STATE OF NORTH CAROLINA  
DEPARTMENT OF TRANSPORTATION

Subject: **Application for Section 404 and 401 Permits;** Hope Mills Bypass from SR 1141 (Bingham Drive) to SR 1363 (Elk Road), Cumberland County, Division 6, TIP No. U-0620, State Project No. 8.1442601, Federal Aid No. STP-0622(2), \$475.00 Debit work order 8.1442601, WBS Element 34408.1.1

**Subject:** Minutes of the Interagency Permit Drawing Review Meeting held on August 22, 2002 for U-620, Cumberland County  
*February 3, 2003 TCE Responses*

# PLAN VIEW SITE 4

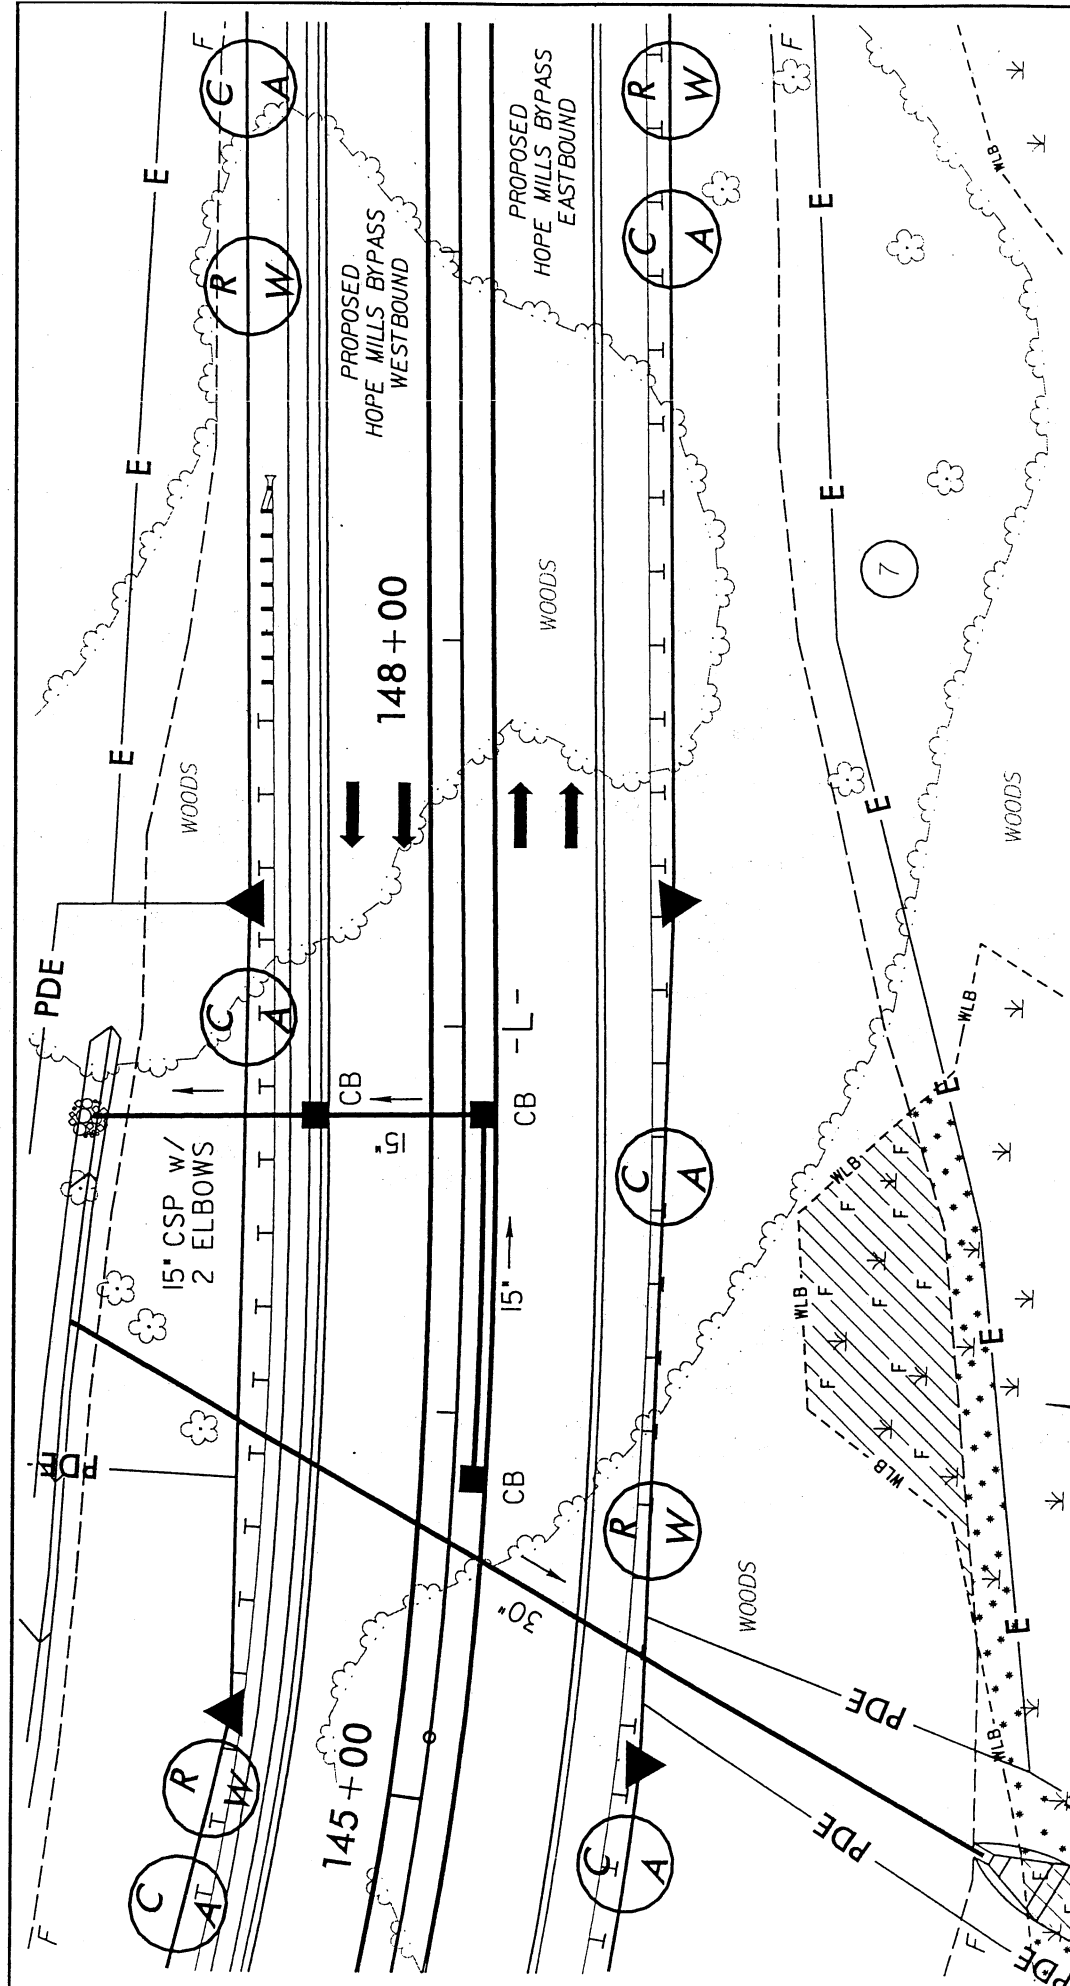
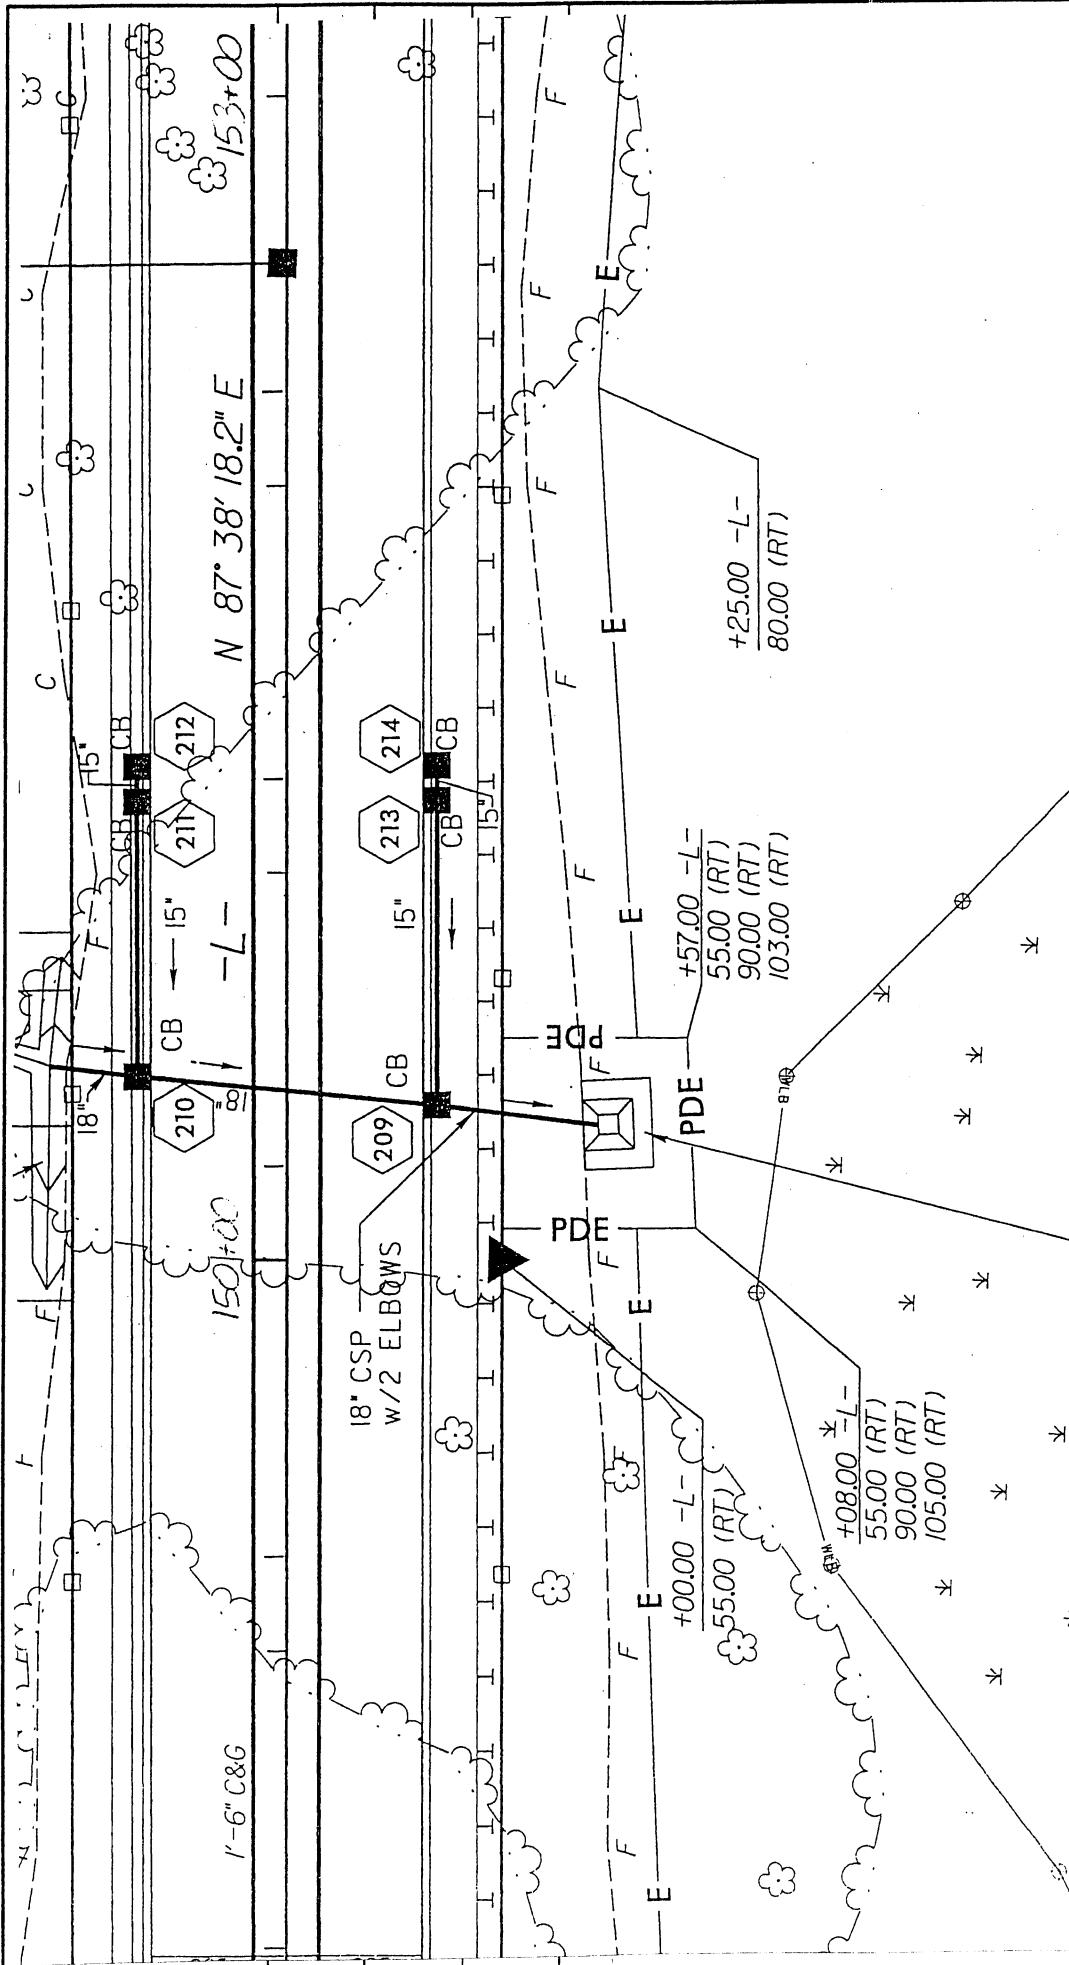
**Sheet 14 (of plans)/current Site 4:** Change stormwater to discharge to the right, outside of wetlands.

Investigate some type of energy dissipater at end of 30" cross pipe. Even if this has to encroach into wetland, agencies prefer over allowing the velocities to cut a channel through the wetland. (This also needs to be investigate between station 150-155 on plan sheet 14)

Site 4. An energy dissipator basin has been placed at the outlet of the 30" RCP (sheet 14 of 27) and a preformed scour hole has been placed at the outlet of the 18" RCP right of -L- Sta. 150+30 (sheet 13 of 25).

# PLAN VIEW SITE 5

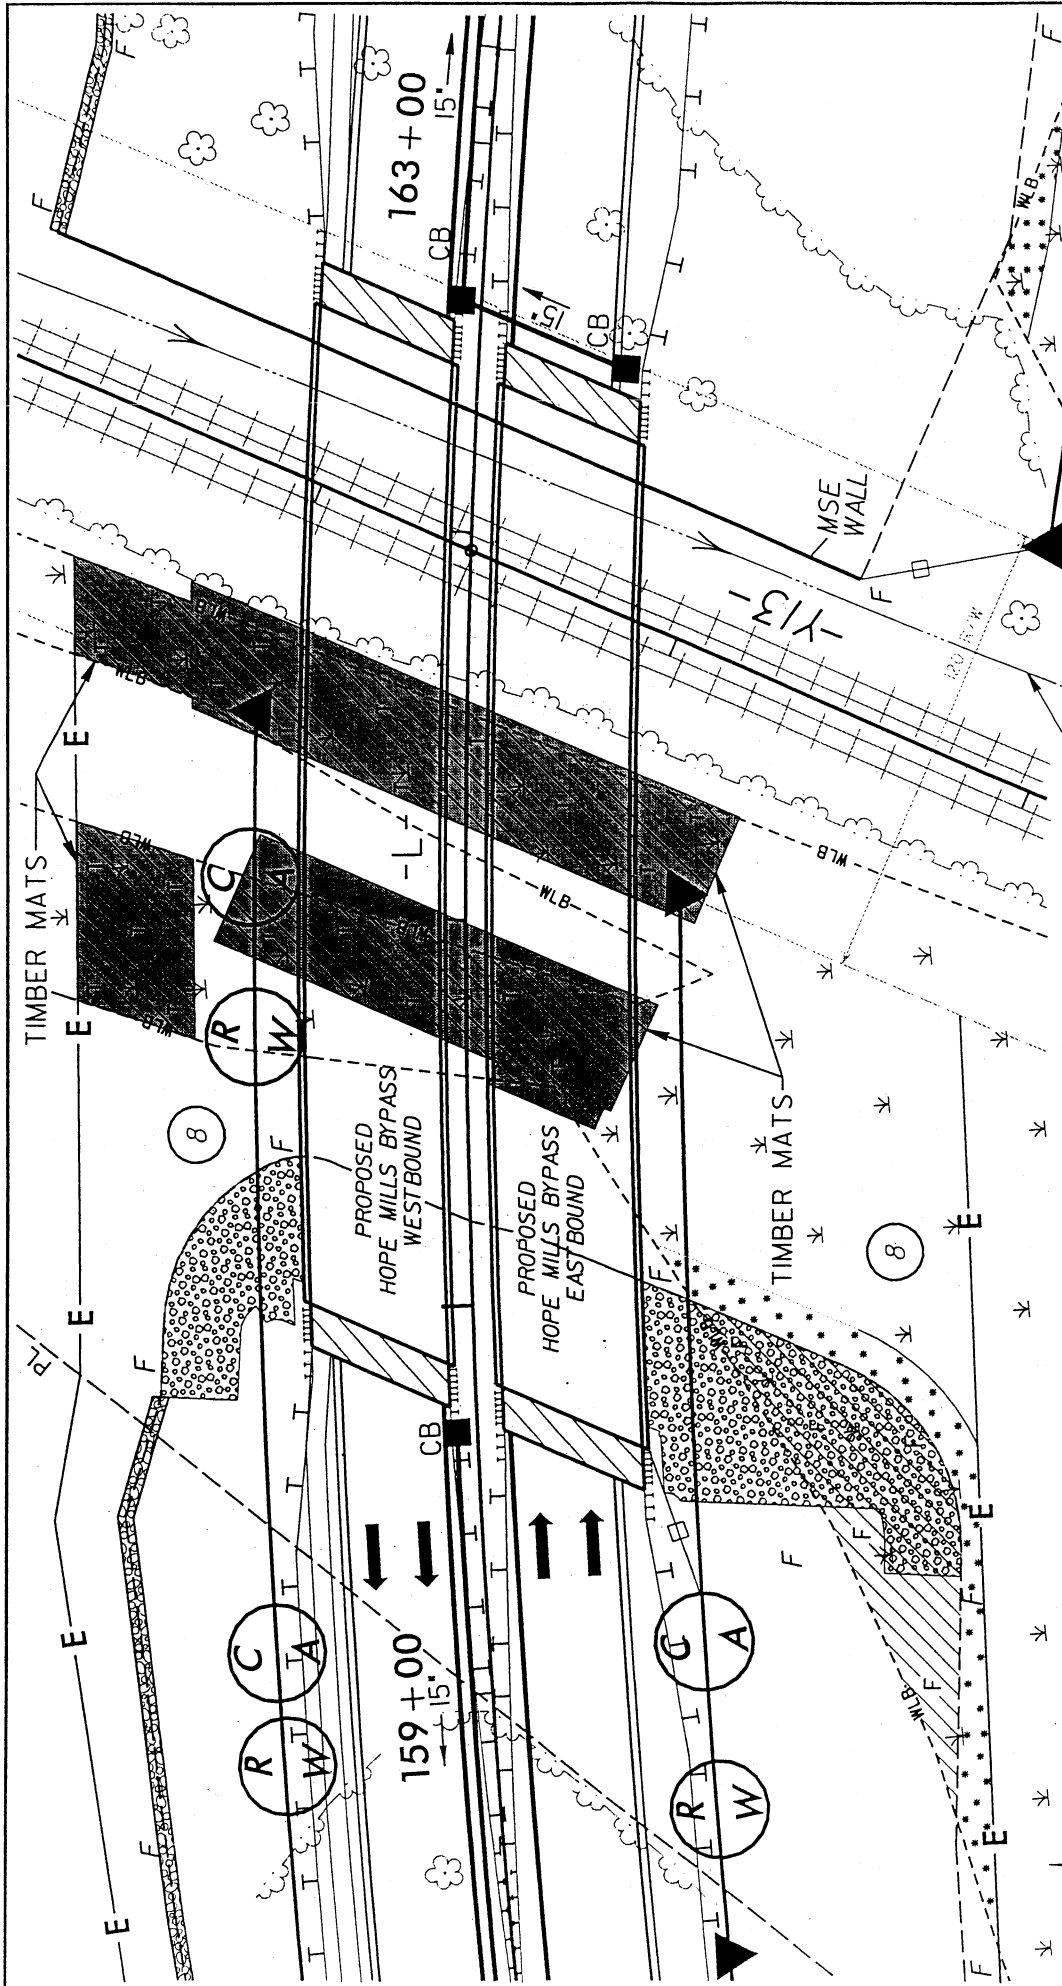
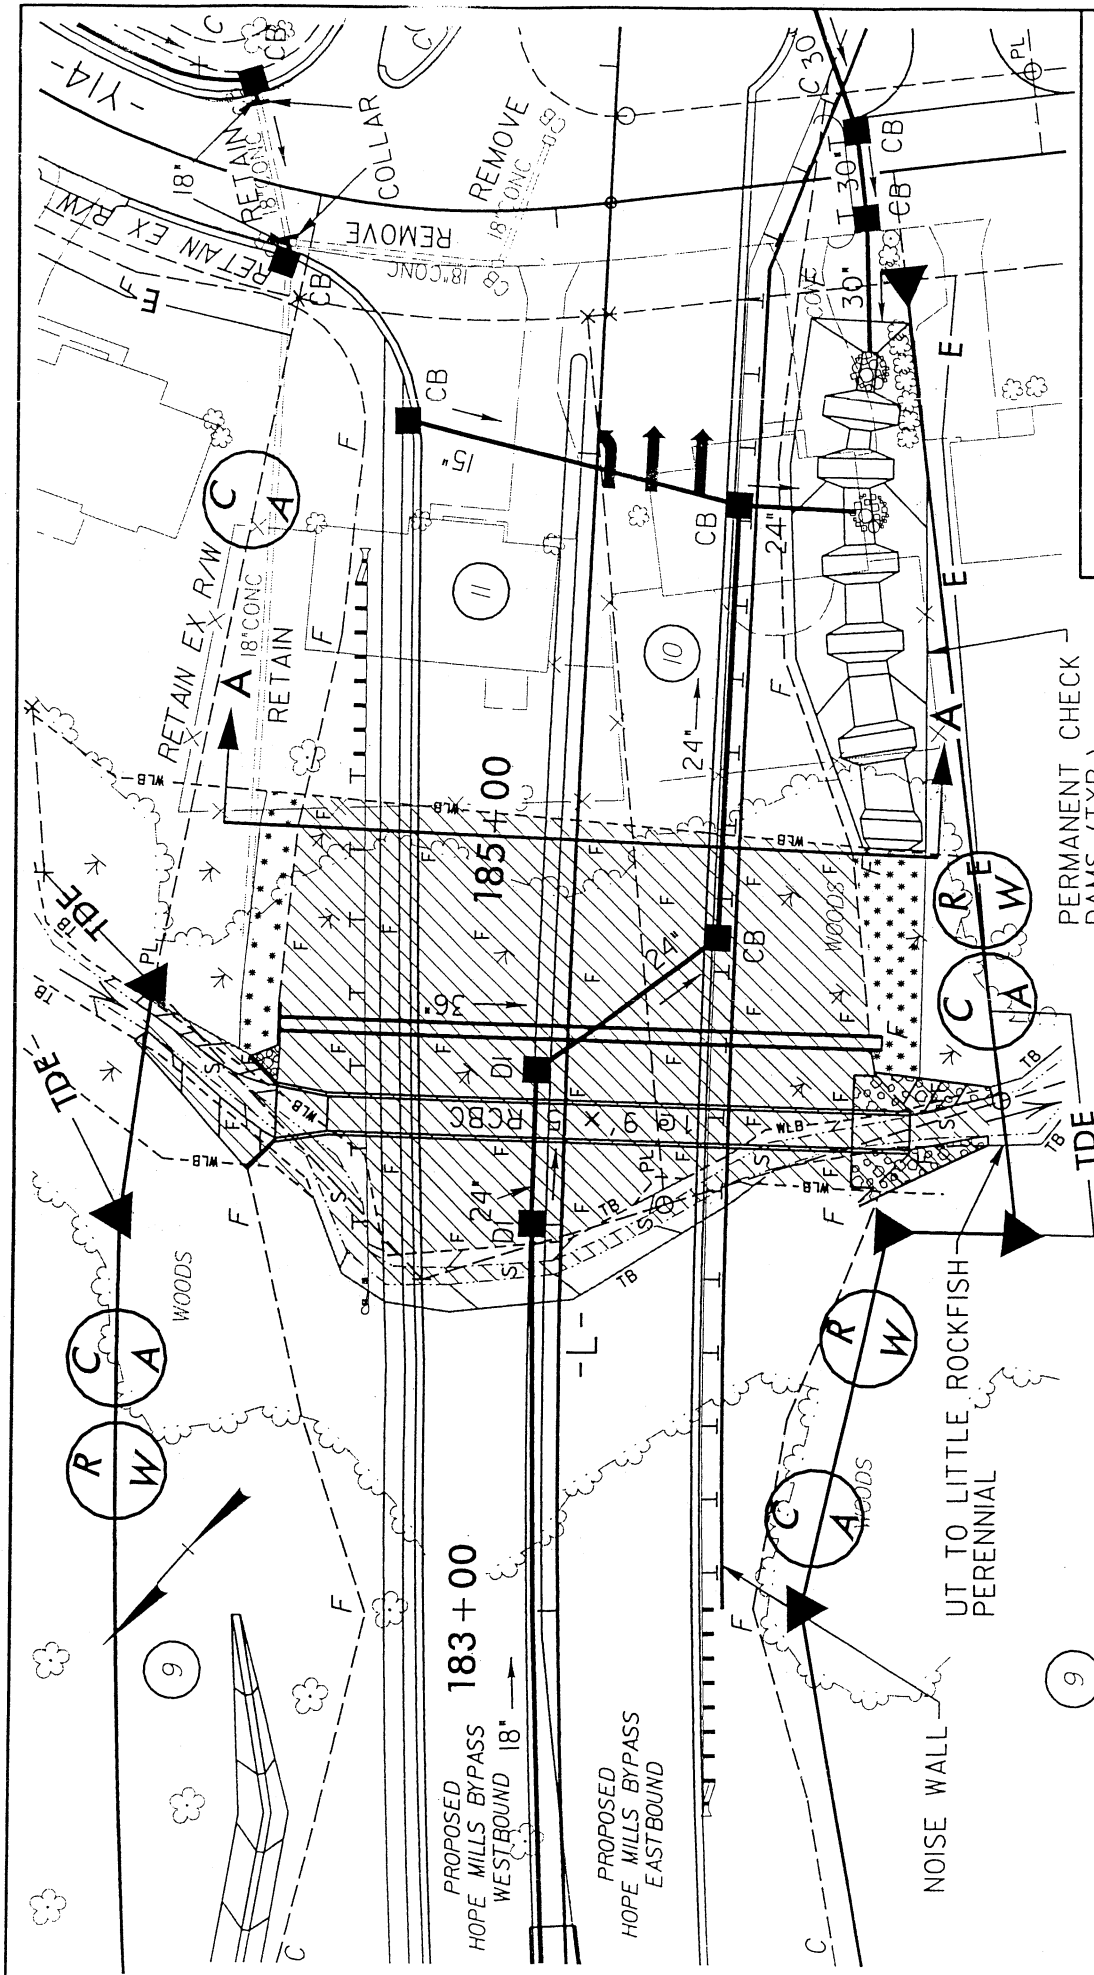
**Sheet 15 (of plans)/current Site 5:** OK. However, drawing is needed for discharge pipe into wetland at station 165+00 on plan sheet 15.

***Per discussions with Marshall Clawson, a formal permit drawing will not be required. Marshall advised that an 8 1/2" x 11" copy of the revised designs would be adequate. A preformed scour hole has been added right of -L- Sta. 164+50.***

# PLAN VIEW SITE 7

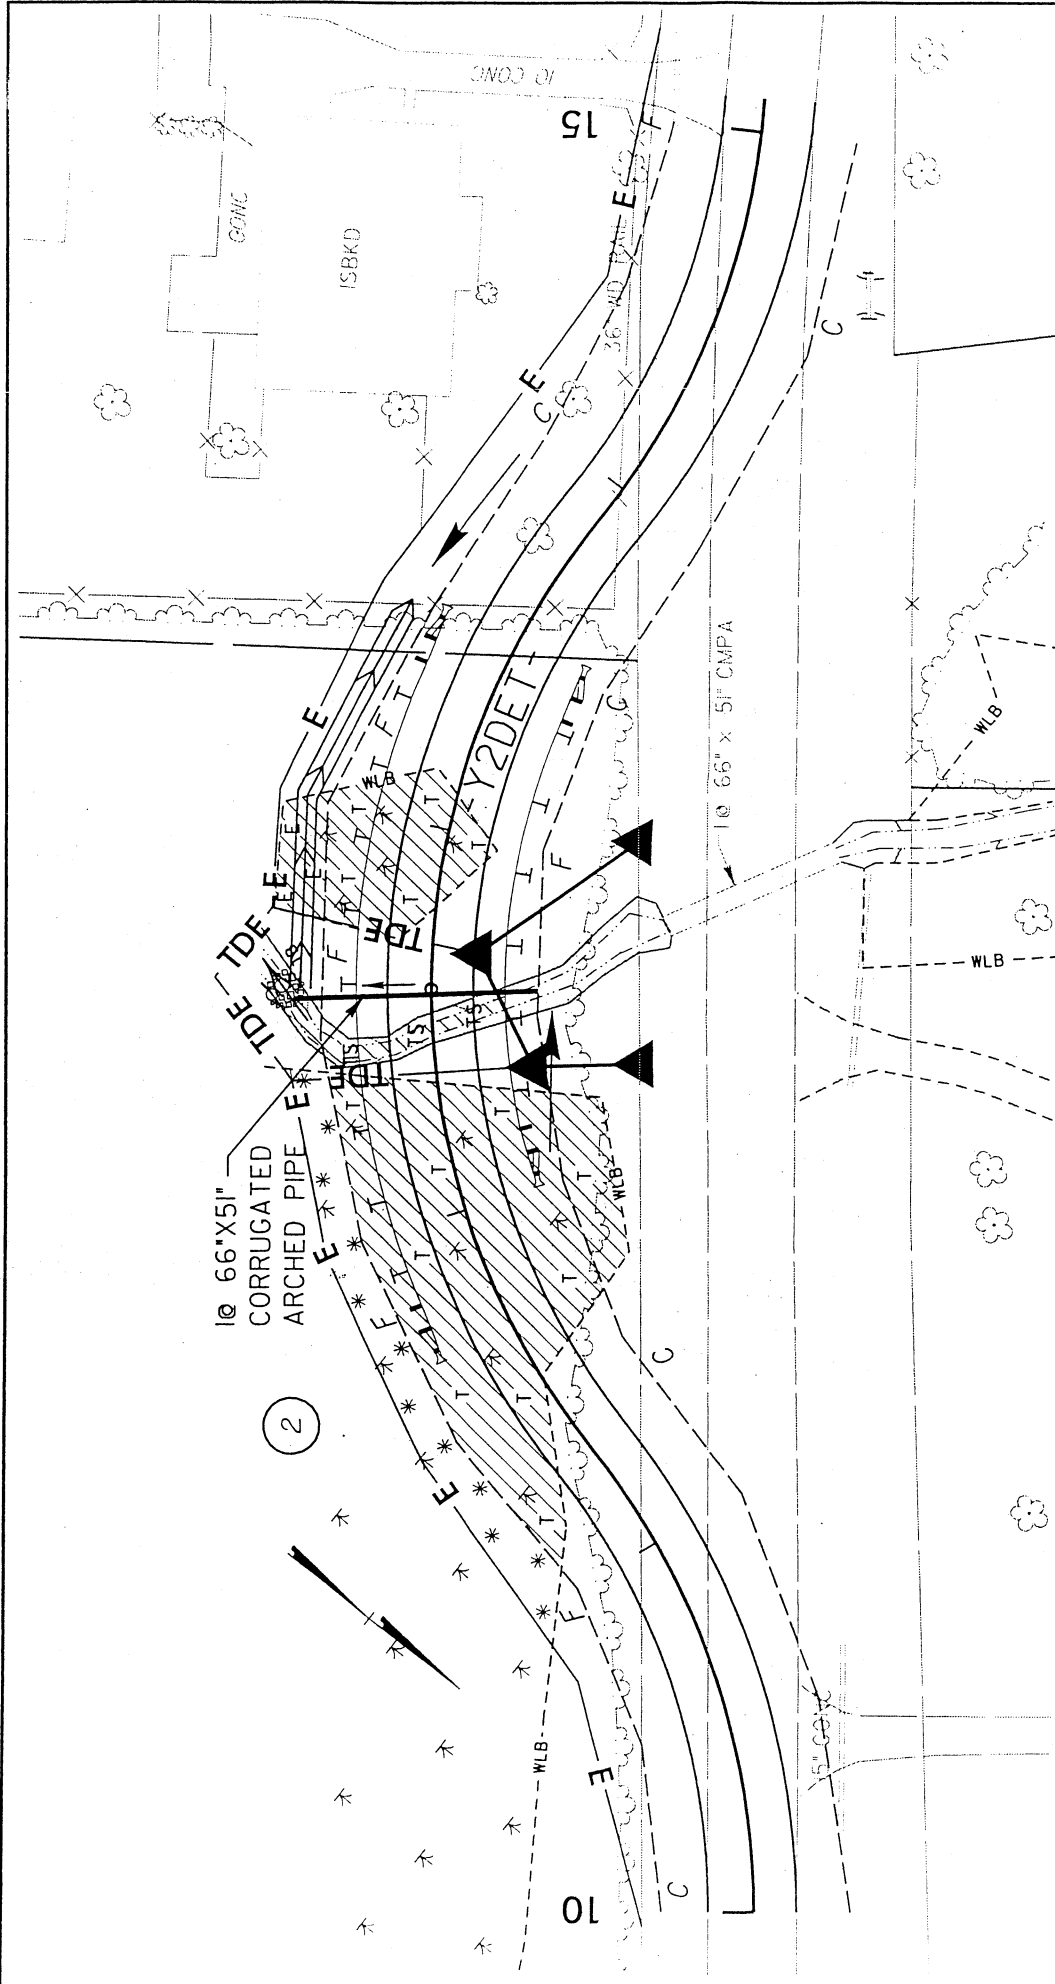
**Current Site 7:** OK

***No action required.***
